NOTICE OF DENIAL

RE: Application Number 21-7360; 1321 Labrosse; Corktown Historic District

RE: 1321 Labrosse Street – Application Number 19-6555

Sheet Number:
A5.10

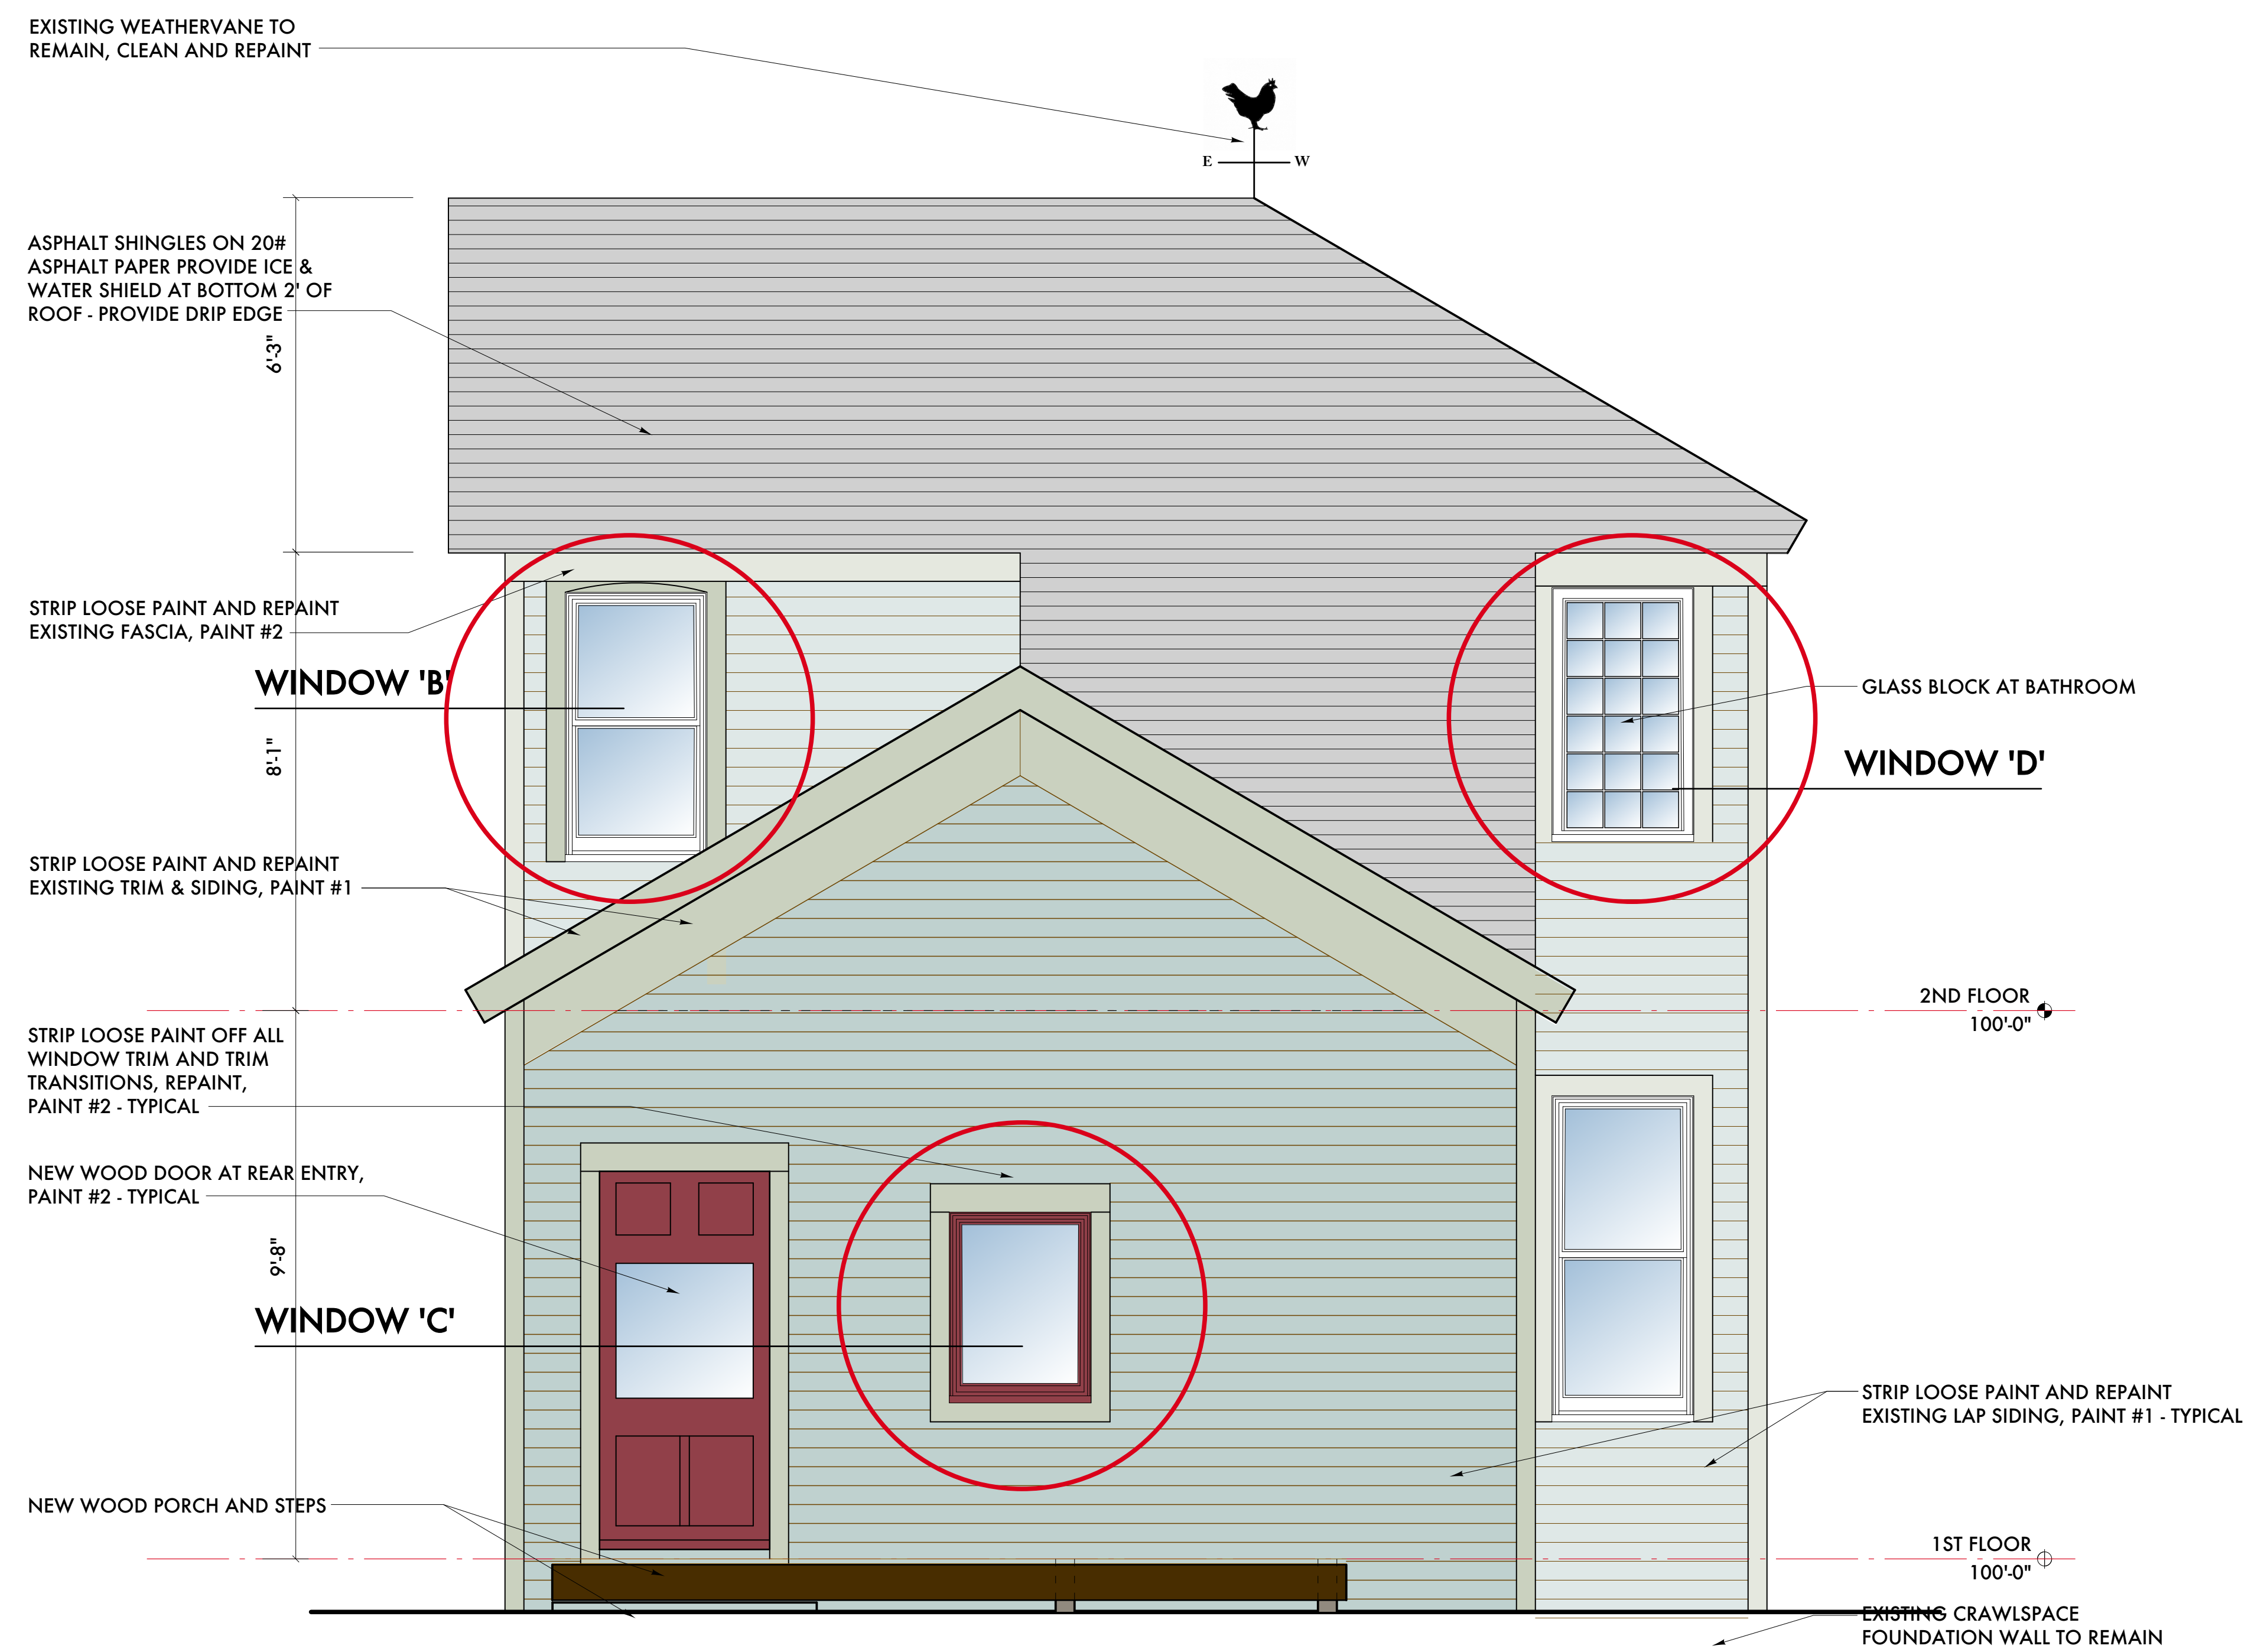
- Removal of two window openings: first story, small double-hung window adjacent front door; second story window opening above front porch.

- Removal of one historic, wood double-hung window on the second story, and installation of one double-hung, one-over-one vinyl sash (clear glass), color: white.

Window E – This opening was boarded over the interior and exterior of the house. When the plywood was removed on the exterior and the finishes on the interior, whatever window opening may have been there at one time is long since gone. The opening had been framed and infilled, there were not any window frames or any other elements of the window left. Instead of putting plywood back, we used the same wood siding to frame over the entire face of the house.

Window F – This was the former window installed next to the door. The original idea was to put this window back but after reviewing the window, an aluminum, single lite (non-insulated" window that was not historic to the original windows, we decided to not reinstall this window. The damaged caused to the interior sill by the sweating of the window was repaired, the exterior boarded over with the wood siding and the interior covered with gypsum board and painted.
